Wollongong Local Planning Panel Assessment Report | 30 November 2021

WLPP No.	Item No. 2
DA No.	DA-2021/890
Proposal	Demolition of existing structures and construction of mixed use development
Property	7-13 and 15 Gladstone Avenue, WOLLONGONG
Applicant	Kingdom Developments 5 Pty Ltd C/- The Planning Hub
Responsible Team	Development Assessment and Certification - City Centre Team (RW)

ASSESSMENT REPORT AND RECOMMENDATION

Figure 3: Site photo of connecting structure overhanging the adjacent laneway

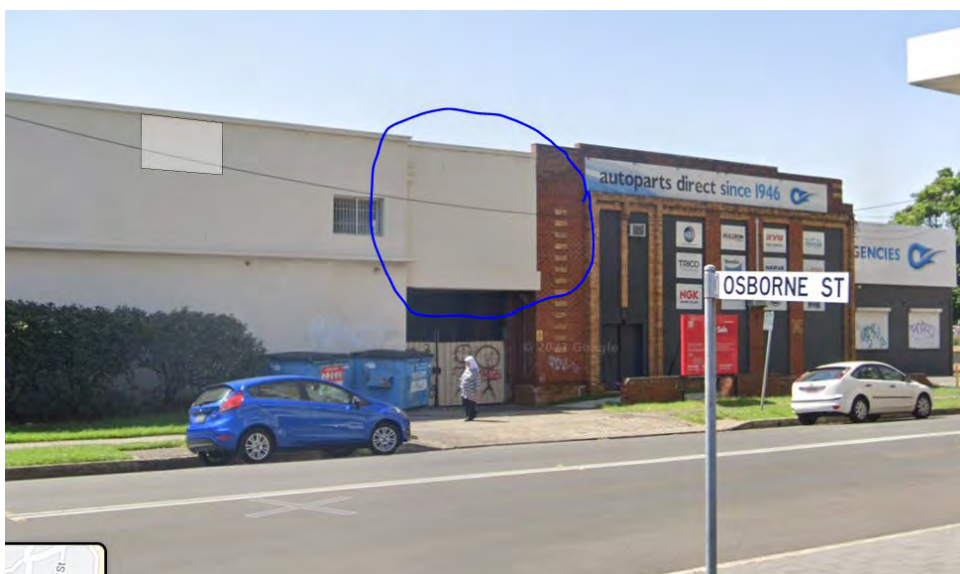
Aside from the survey plan, the submitted documentation does not identify the attached structure on the plans or outline what the intentions are with regard to interface with structure or maintaining its structural adequacy. The structure is attached to the building to the north (Lighthouse Church); however no further information has been provided as to the status of this structure. Council records indicate the structure is identified on the title of the adjoining site (Lot 1 DP 1197161 known as 1 Railway Station Square) which benefits from an easement for support. Landowner's consent from the neighbouring property for any works to, or demolition of, the overhanging structure has not been provided. Further investigations by the applicant will be required to address this issue.

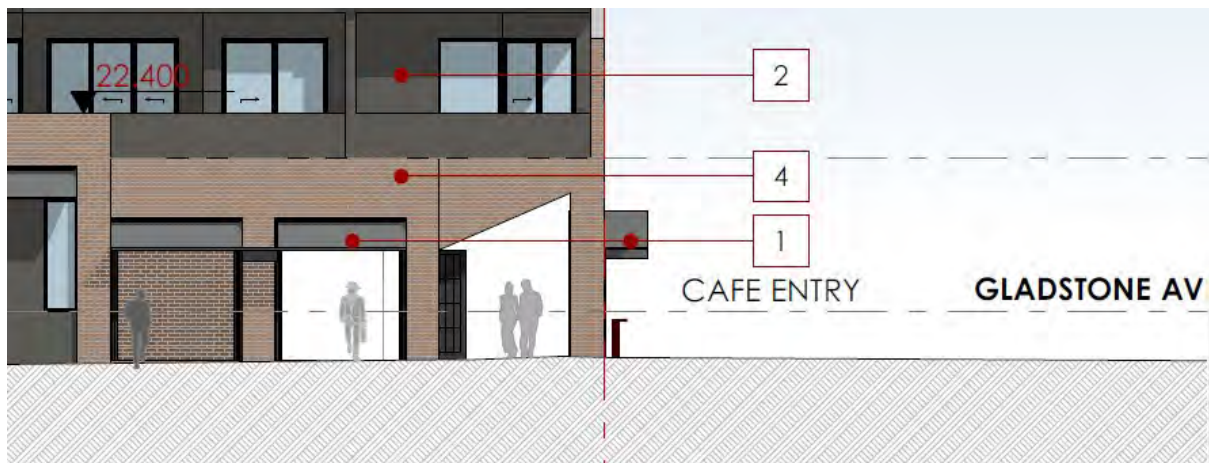
A narrow Colorbond awning is proposed in conjunction with a colonnade, as shown below:

No variation has been sought by the applicant, presumably on the basis that a colonnade is proposed.

The colonnade may provide shelter for pedestrian activity in lieu of an awning, however further detail on how pedestrian access through the colonnade would be maintained needs further clarification (eg – this may require an easement for pedestrian access; however how does this impact on the operation of the café given the proposed outdoor seating?).
